Access Compliance Report Public Rights-of-Way (Curb Ramps)

Main Street: DALL_LN Cross Street: JOSHUA_LN Location: SW

ADA ID: RPAT211026145428 Ramp Type: Type 1 - Perpendicular Diagonal Initial Pass/Fail: Fail Overall Compliance: No Severity Score: 16

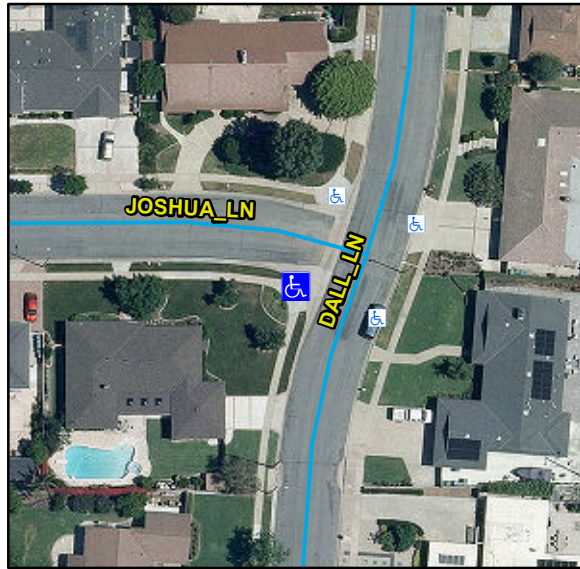
R304.2.2, R204.3, STD 1115

Remove & Replace Curb Ramp With Two New Directional Ramps or Equivalent.
